Tennant AMR Software 3.9 Update

3.9 Clean App Overview

No-PIN Workflow & Access Control

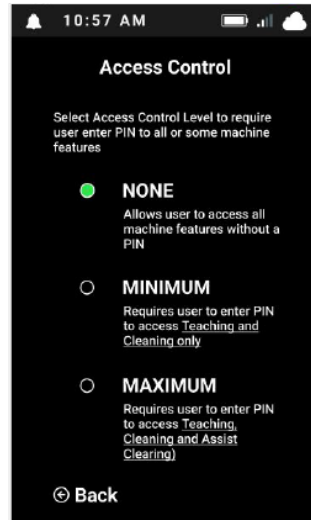
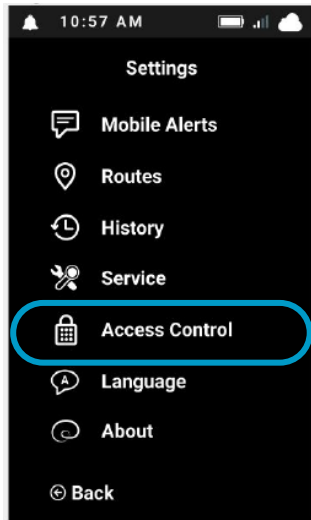
- The new Access Control option, **None**, allows operators to use the machines **without** the PIN for key operational tasks such as **Teaching**, **Autonomous Cleaning**, and **Clearing Assists**
- Customer benefit:** a barrier to usage is removed
- Most machines will be set to Access Control Level: None at launch (except for machines already set to the previous Joyride Prevention Level 2)

Language Preference Accessibility

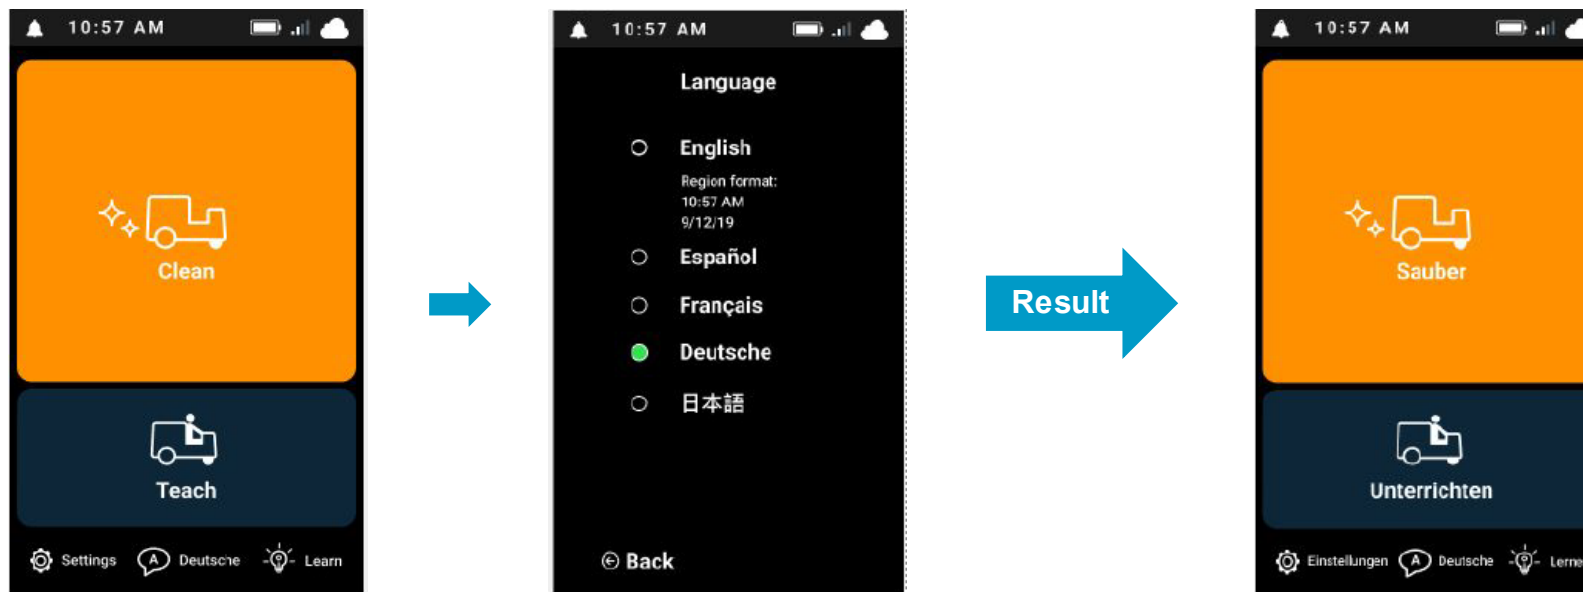
- Setting the language on the UI has never been easier! Now, the language setting is accessible from **the main screen**; the user will no longer have to navigate through the system settings in order to select their preferred language.
- **Customer benefit:** multilingual users or non-English speakers can operate the machines with the language they are most comfortable with.
